College Brook as *19-21 Main Street* “Drain”

*A déjà vu **Conditional-Use** application*

Adapted from Comment at Planning Board Public Hearing
January 27, 2021

Joshua Meyrowitz

Applicants' *Photoshop* rendering, proposed structure.

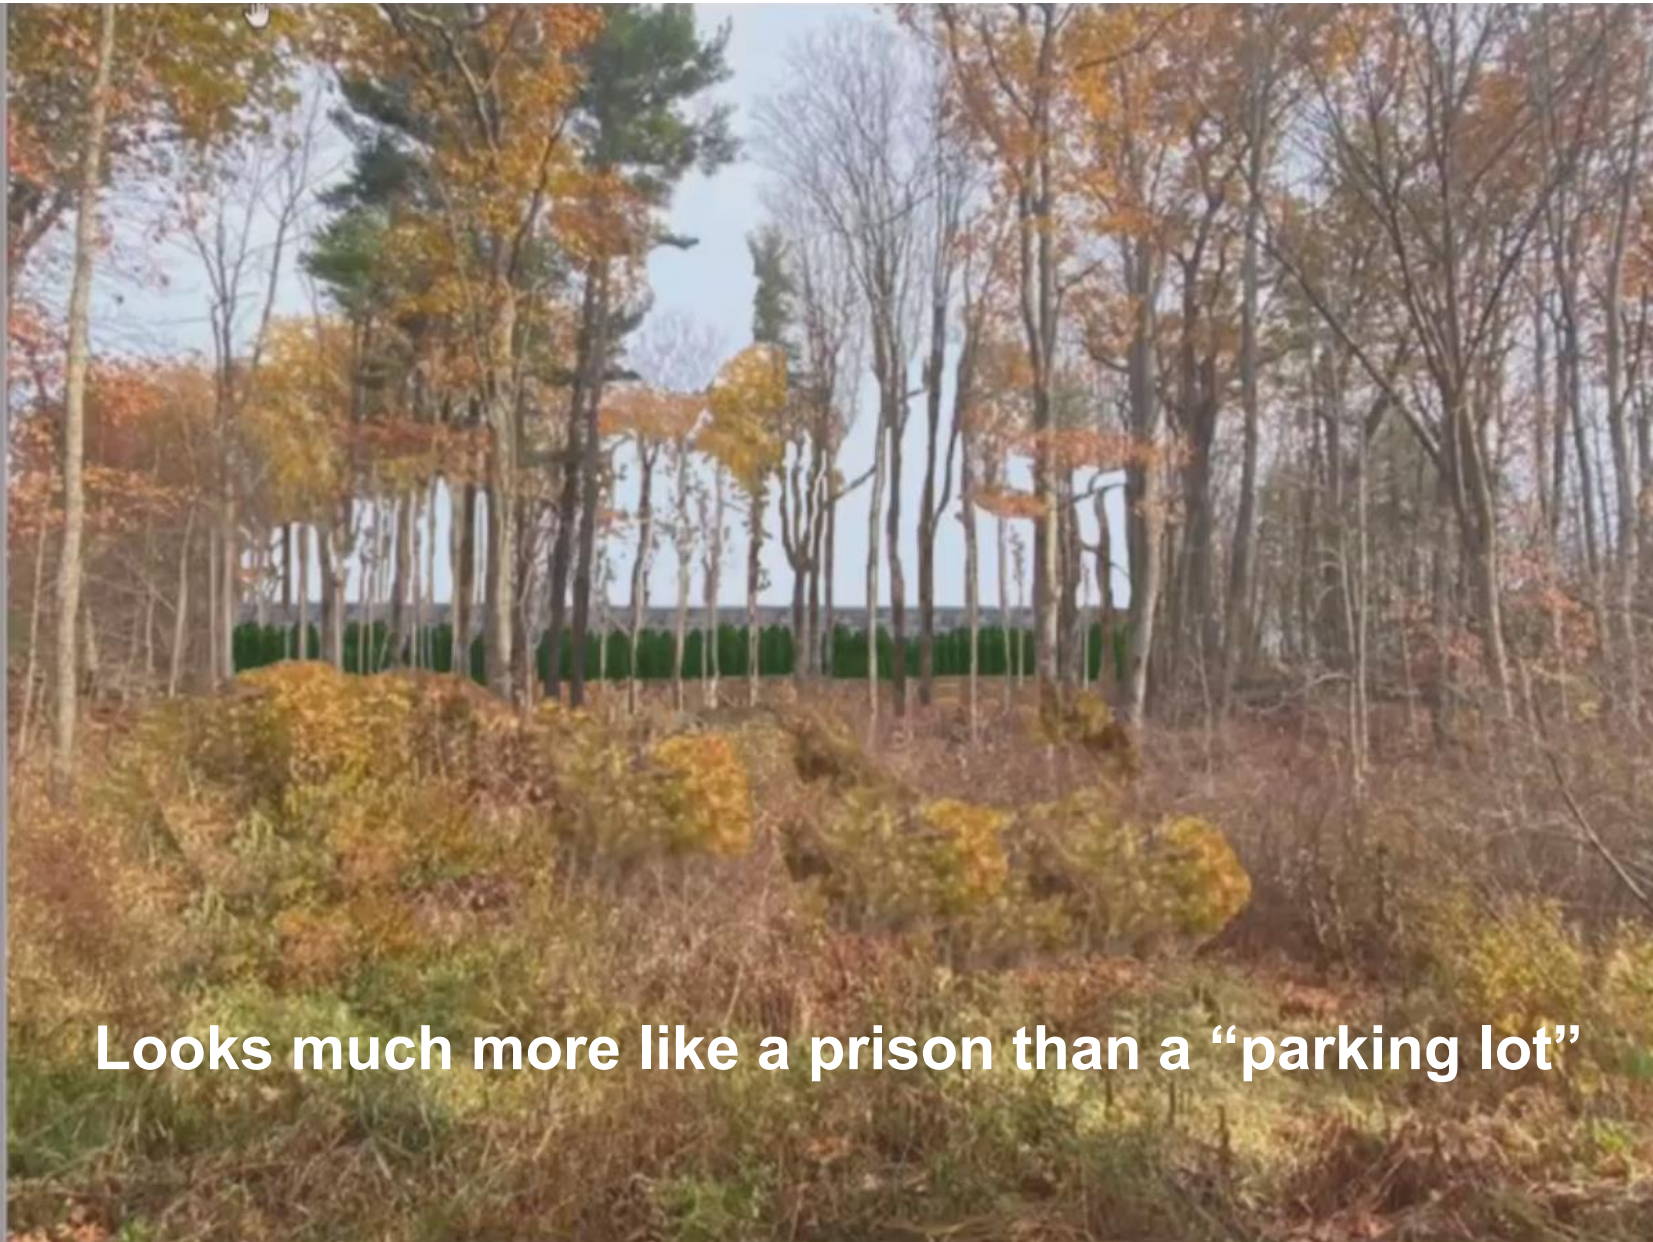
Not shown: 30" black aluminum fence at top, and not shown: 18'-tall lighting poles.

Looks much more like a prison than a “parking lot”

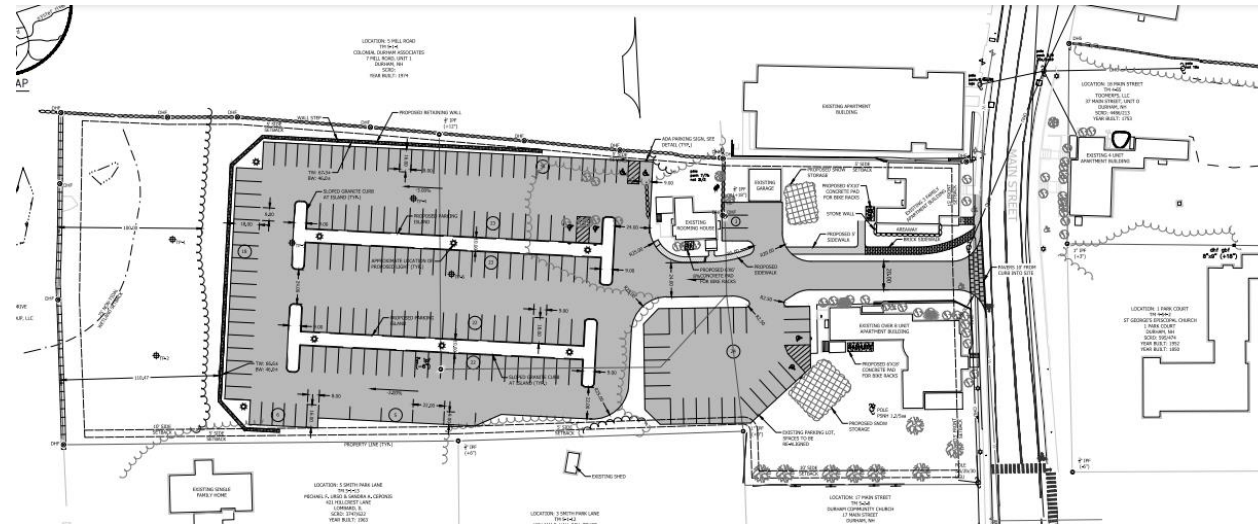
Adding 140~ vehicles (cars, trucks, snow plows, towing vehicles, snow-melting machine) to what is **now quiet woods**, *(with no other existing lots towering over adjacent homes)* would obviously bring the **not-allowed vast increase** in “**odors, vibrations, dust, fumes, and hours of operation.**”

NOT SHOWN:
30" wall-topping
black aluminum
fence, and

Not Shown:
Supposedly
glare-free
18' Lighting
Poles – *to*
be on ALL
night.
